Submission for Job: #6011 SSD 6011 - Mixed use residential development within the South West Plot

Site: #2825 SICEEP Site, The Haymarket; Darling Drive, Sydney

SSD 6011 - Mixed use residential development within the South West Plot

LEVEL 6

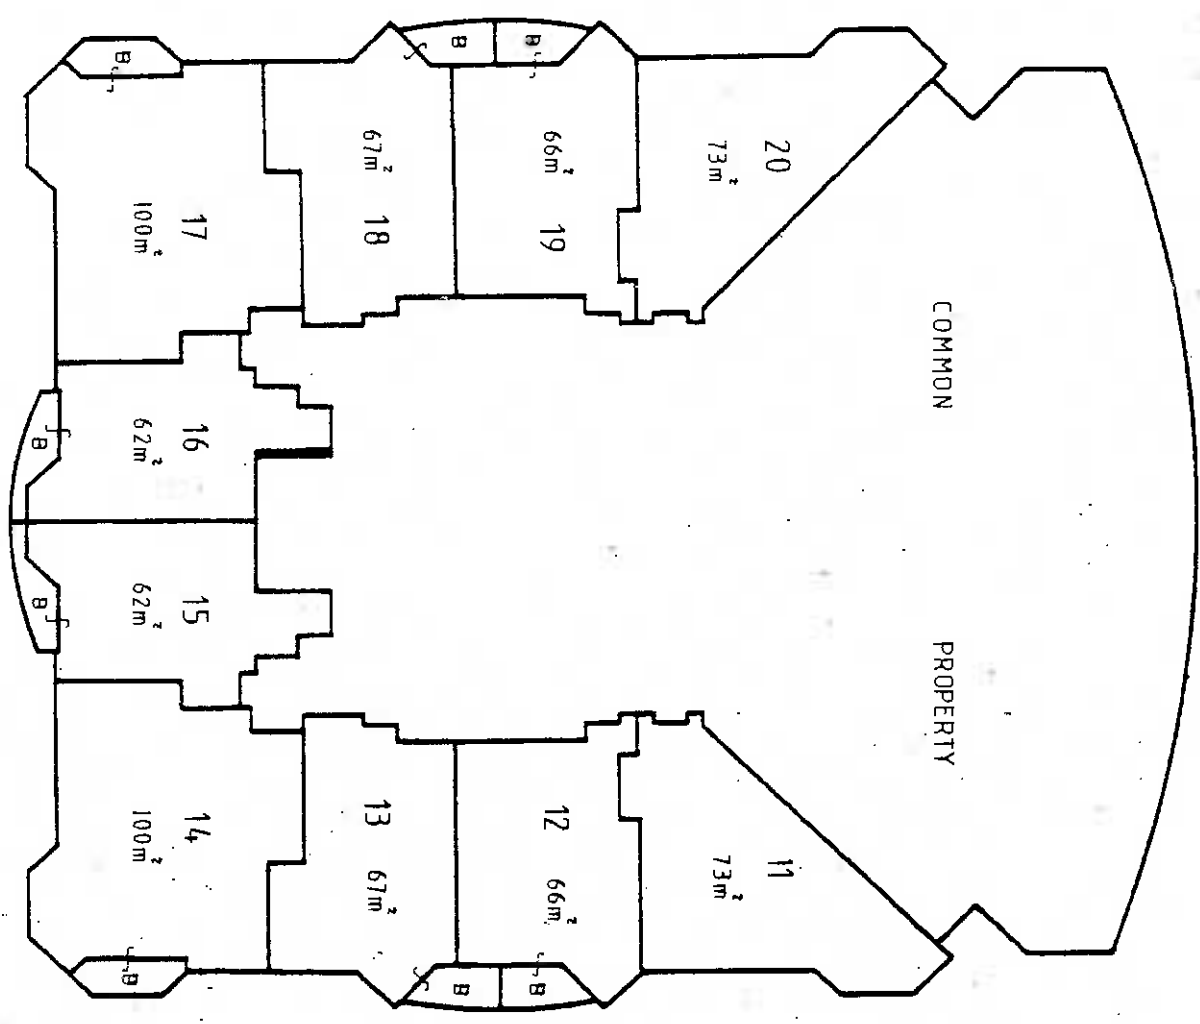
Levels 6 and 7 each contain two apartments with single west aspect , i.e. 4 single aspect apartments.

LEVEL 8

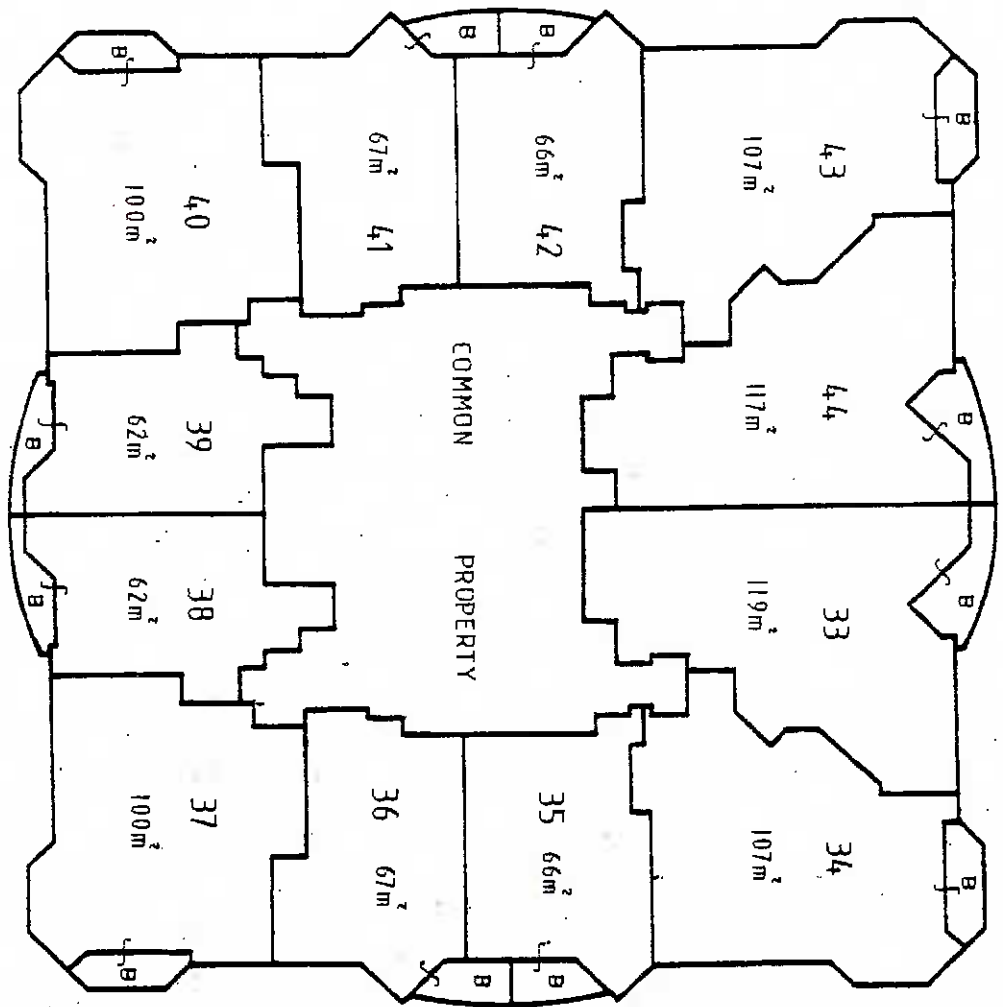
Levels 8-15 each contain two apartments with single west aspect and two apartments with single north aspect , i.e. 4 single aspect apartments per level, giving 32 single aspect apartments.
